**APPLICATION FOR PERMISSION
UNDER SECTION 16 OF
THE TOWN PLANNING ORDINANCE
(CAP. 131)**

根據《城市規劃條例》(第 131 章) 第 16 條遞交的許可申請擬議在
新界元朗石崗丈量約份第 114 約地段第 598 號 C 分段 (部分) 和毗連政府土地
作擬議臨時物流中心 (為期 3 年)

Response to Comments on Temporary Drainage Proposal (Issue 2)

寄件者: [REDACTED]
寄件日期: 2024年12月04日星期三 19:02
收件者: tpbpd/PLAND
副本: Pak Him CHIU/PLAND; Jane Ching Kei LAU/PLAND
主旨: Re: 有關A/YL-SK/386部門意見回覆
附件: DD114_598SC_FS Drawing_20241204.pdf; DD114_598SC-LAYOUT PLAN_20241204.pdf; SK386部門意見回覆_20241204.pdf

PLAN 1

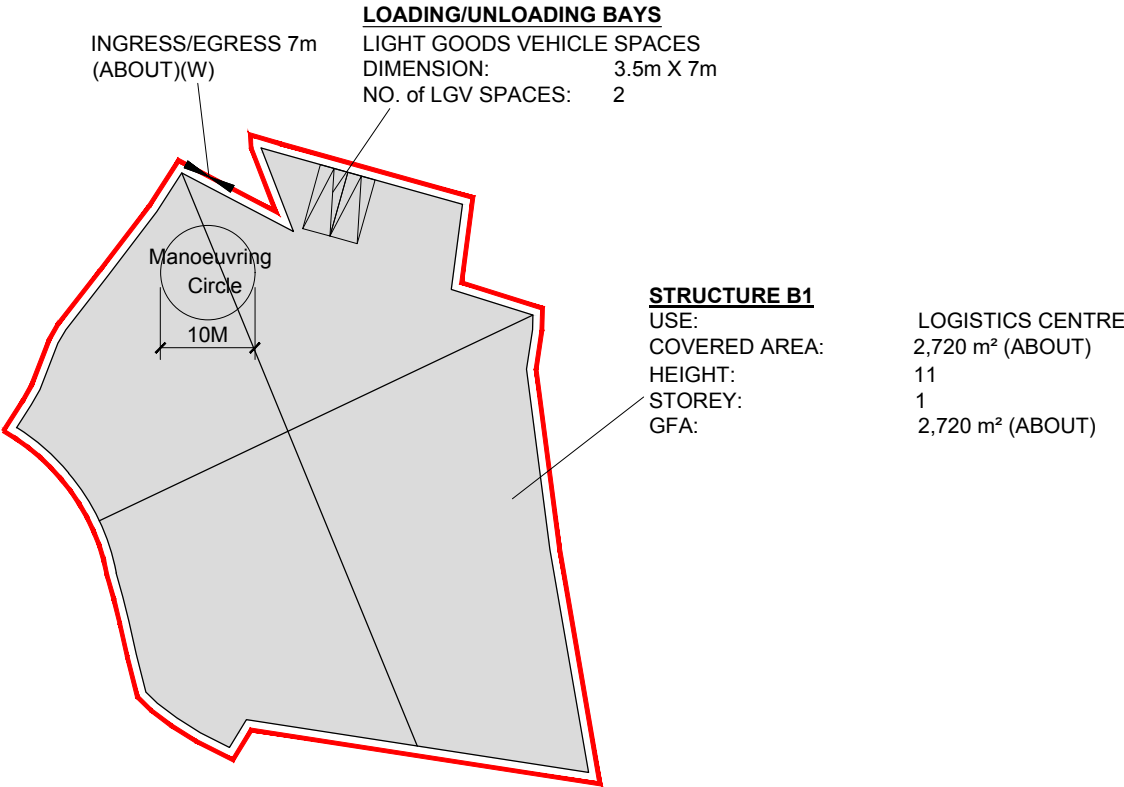
2. 由於一直在等待地政署批出短期租約及短期豁免書，政府土地一直未作使用，所以申請範圍內有一些果樹，分別為荔枝樹 7 棵、香蕉樹 8 棵及碌柚樹 2 棵，主要分佈在 Plan1 中黃色部份的政府土地內，在短期租約及短期豁免書獲批後，會砍伐上述的果樹，以上都是一些普通樹木，而且周邊都是貨倉及露天存放用途為主，不會對自然環境及景觀造成影響。

APPENDIX F
RESPONSE TO COMMENTS

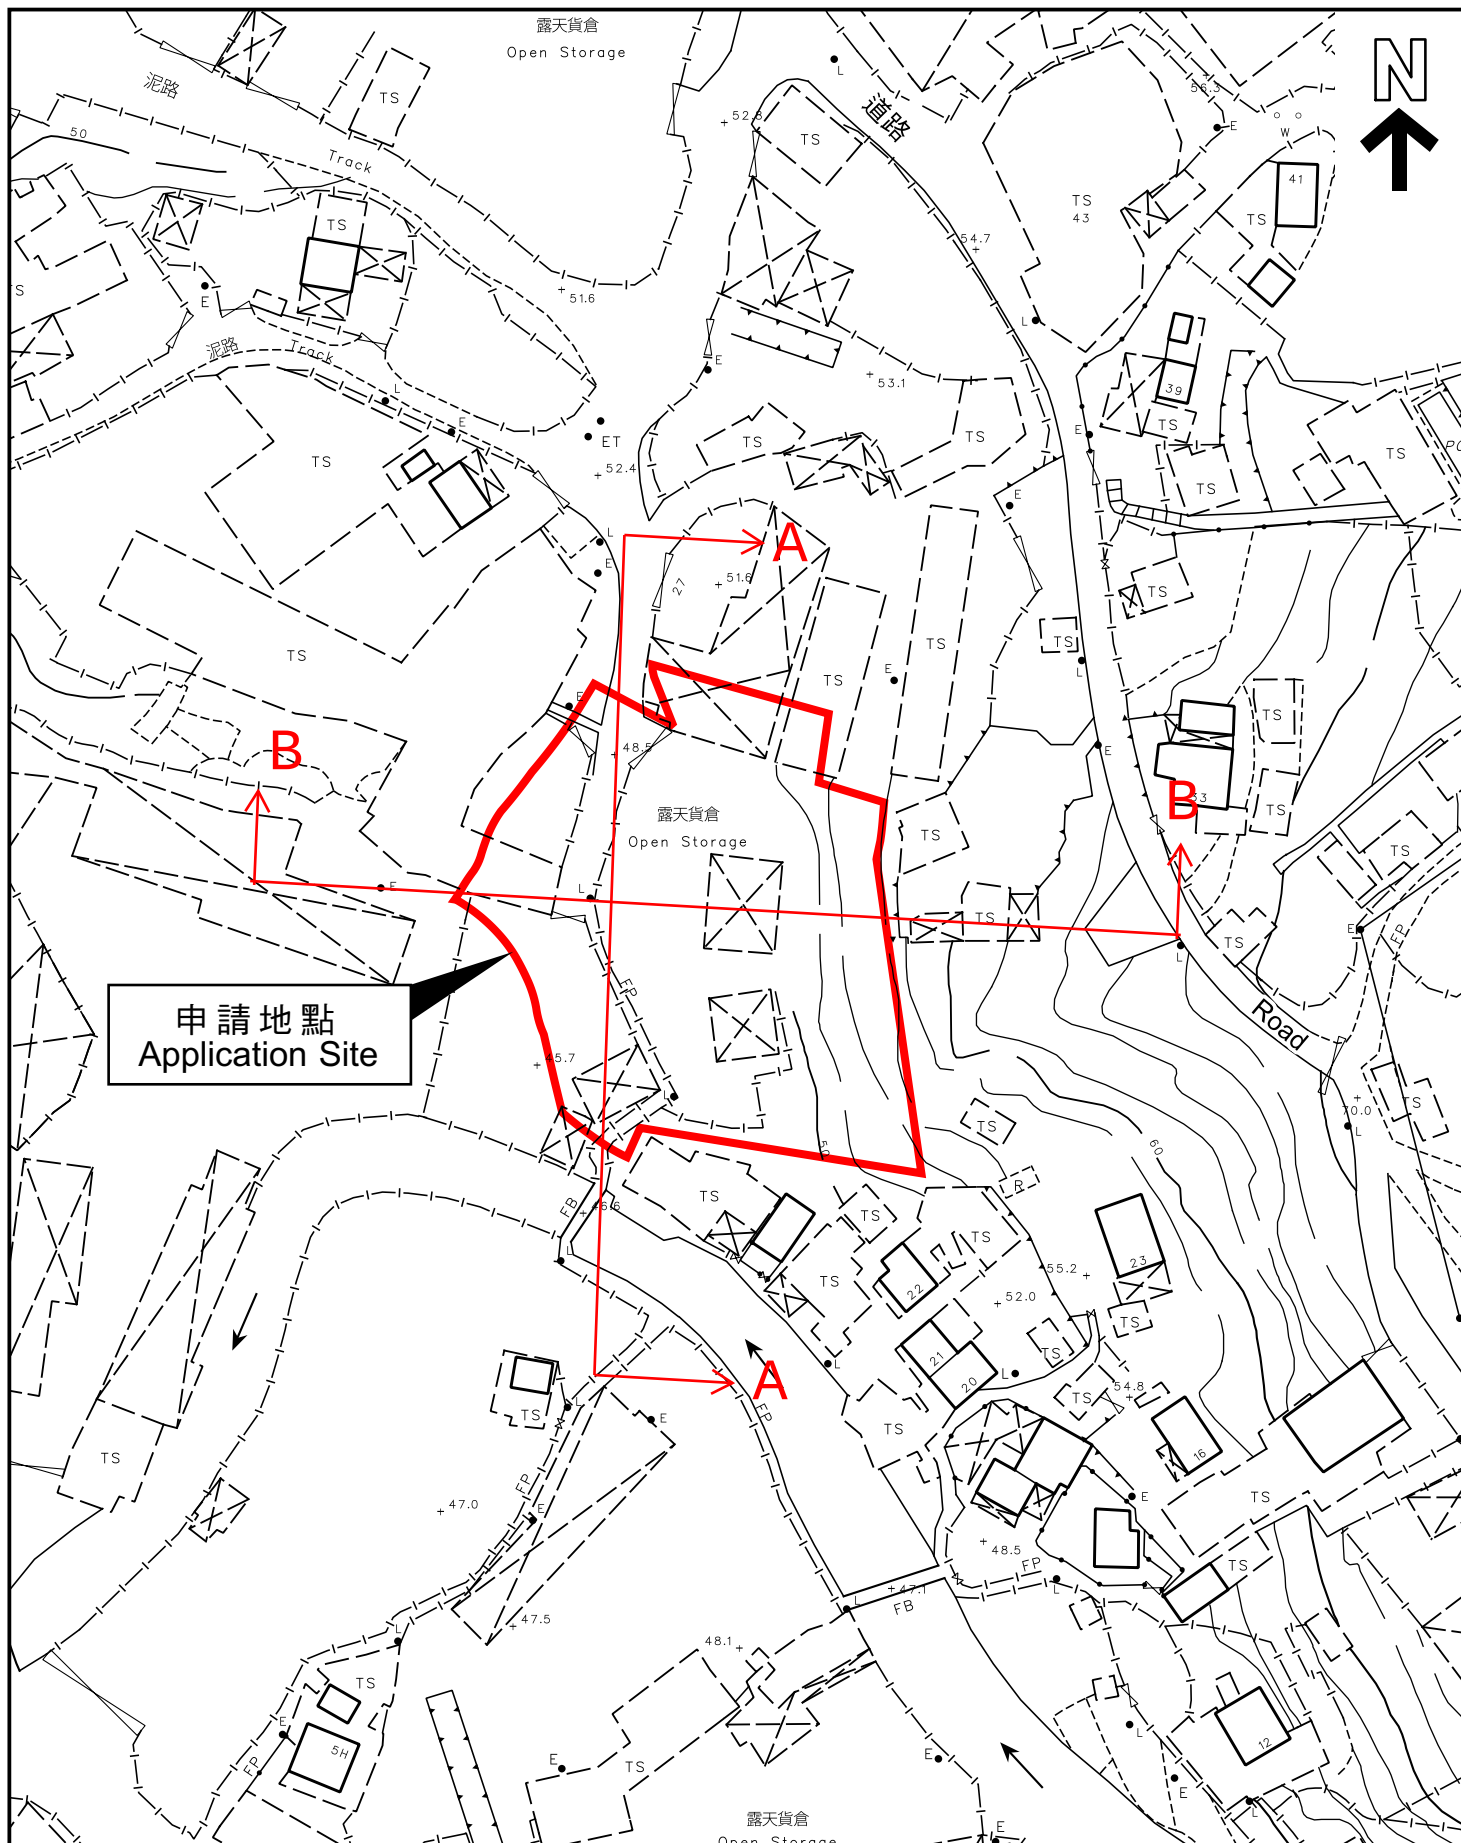
Comment ↵	Response↵
(i) The ground to the east of the application site is generally higher. Since the overland flow from the adjacent lands shall be probably intercepted, external catchment shall be considered in the calculation↵	External catchment area at east is considered and the calculation is revised.↵
(ii) The existing watercourse proposed for discharge of the runoff from the application site is not maintained by DSD. The applicant shall resolve any conflict/disagreement arisen for discharging the runoff from the application site to the proposed discharge point. Moreover, the applicant should ensure that this drainage system and the existing downstream/drains/channels/streams have adequate capacity to convey the additional runoff from the application site. Regular maintenance should be carried out by the applicants to avoid blockage of the system. In the case that it is a local village drains, District Office/Yuen Long should be consulted↵	Noted↵

(iii) Further to (ii) above, since there is no record of the said discharge path, please provide site photos to demonstrate its presence and existing condition; and↵	Site Photos are provided in Appendix H↵
(iv) Cross sections showing the existing and proposed ground levels of the captioned site with respect to the adjacent areas should be given↵	Cross sections are provided in Appendix G↵

APPENDIX G
SECTION

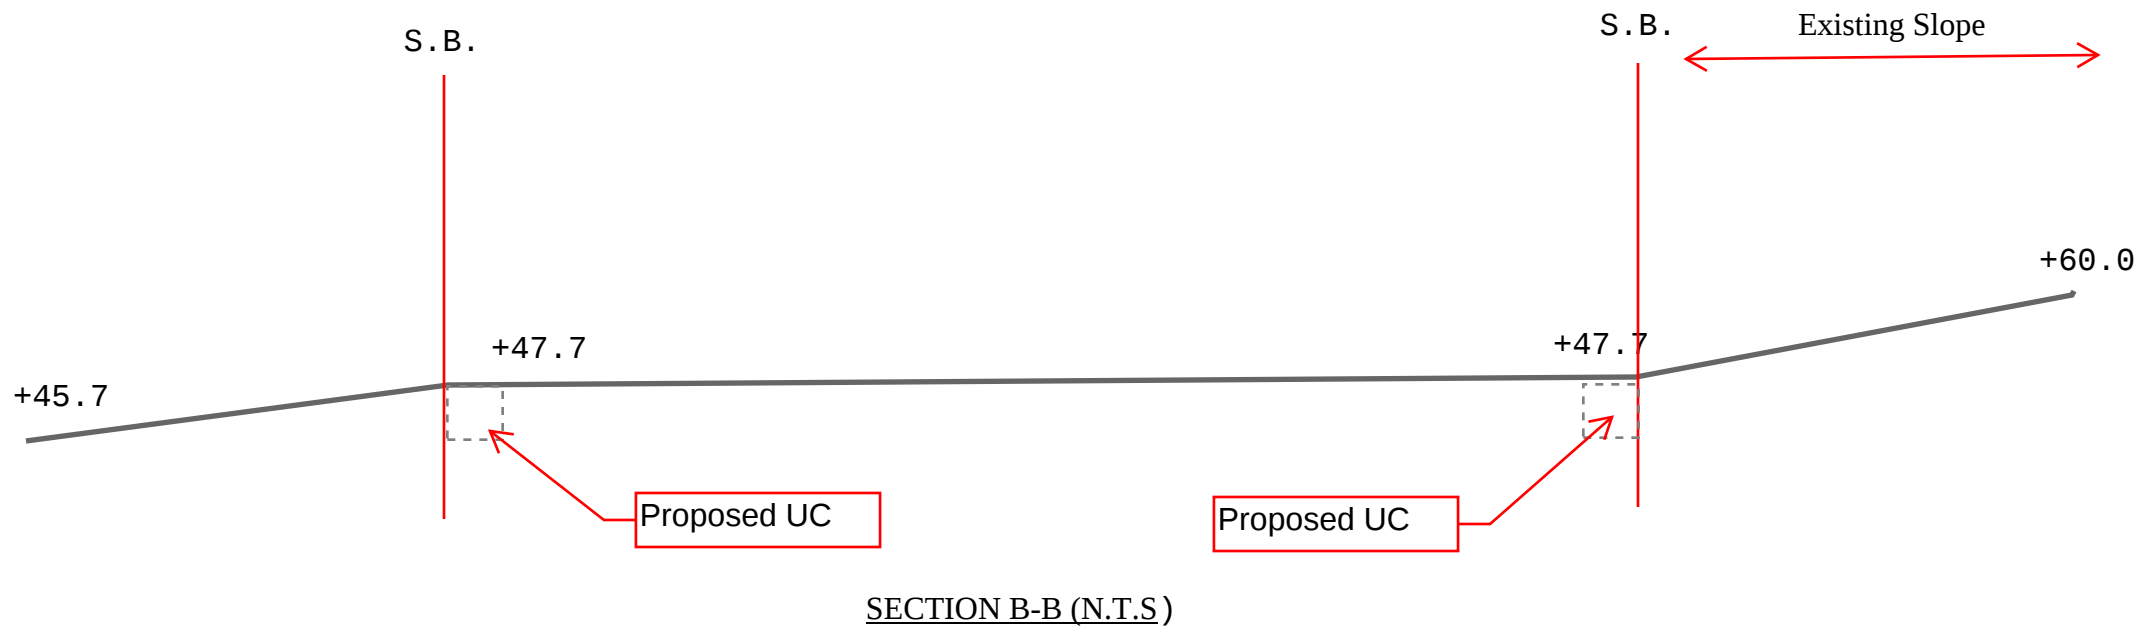
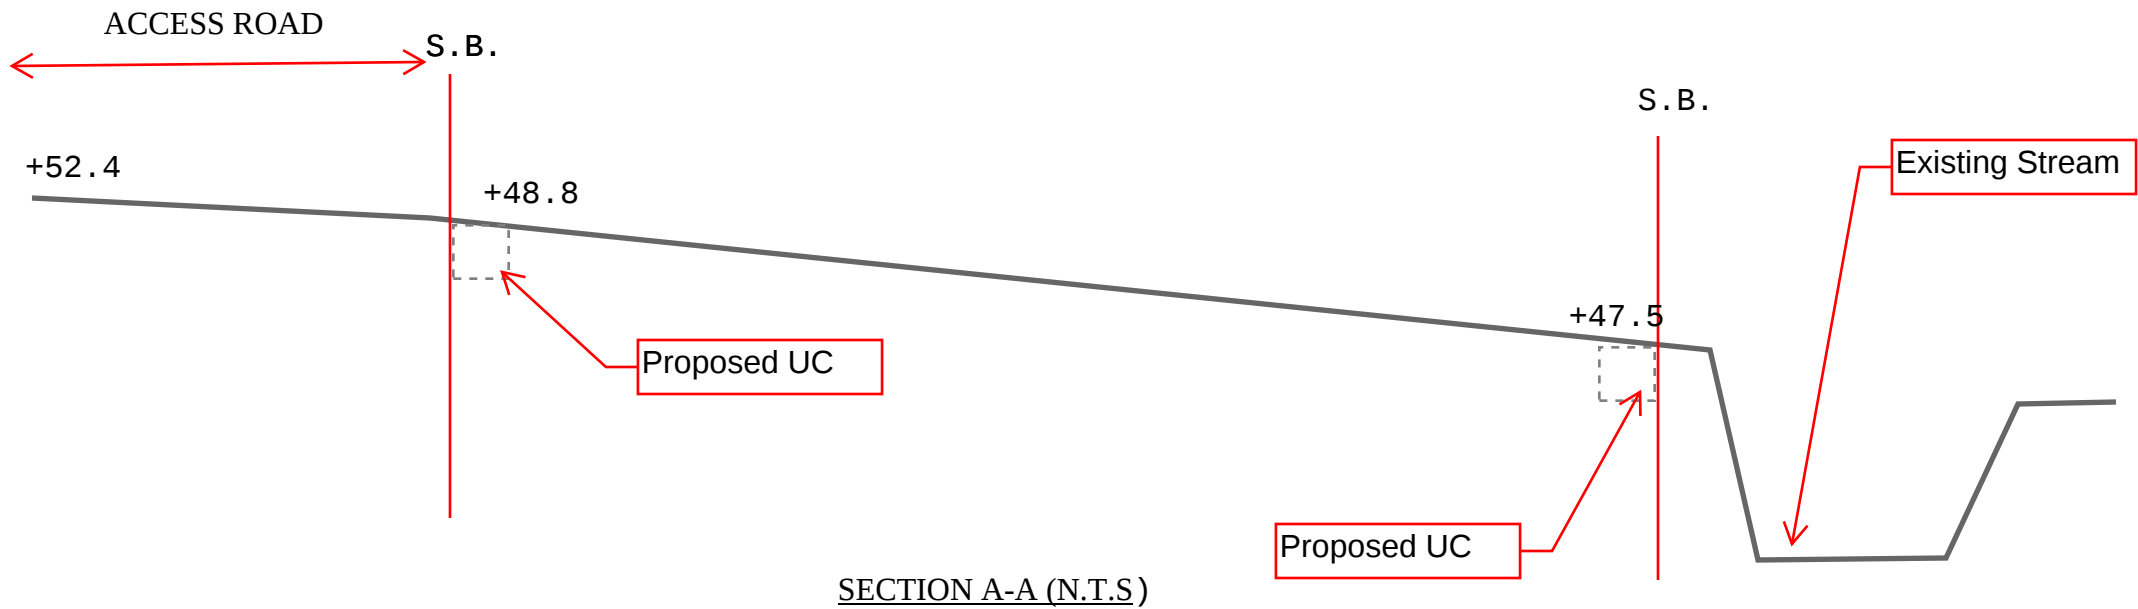
(iii) Further to (ii) above, since there is no record of the said discharge path, please provide site photos to demonstrate its presence and existing condition; and	Site Photos are provided in Appendix H
(iv) Cross sections showing the existing and proposed ground levels of the captioned site with respect to the adjacent areas should be given	Cross sections are provided in Appendix G

DWG NO. PLAN 2	VER. A-1
-------------------	-------------

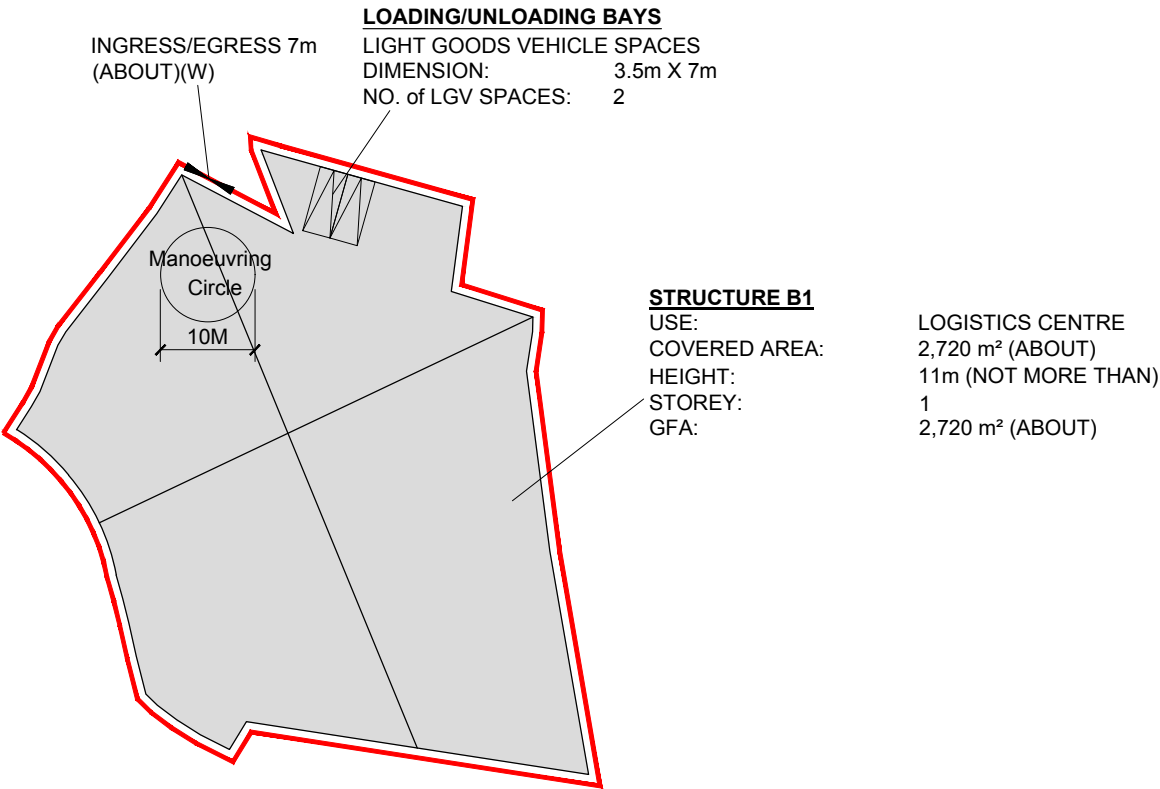
有關 A/YL-SK/386 背景、發展詳情及城市設計及園境組及意見回覆及消防裝置建議及 Plan2 的更正可見附件，此電郵取代 2024-12-04
15:27 及 2024-12-04 18:47 之電郵。
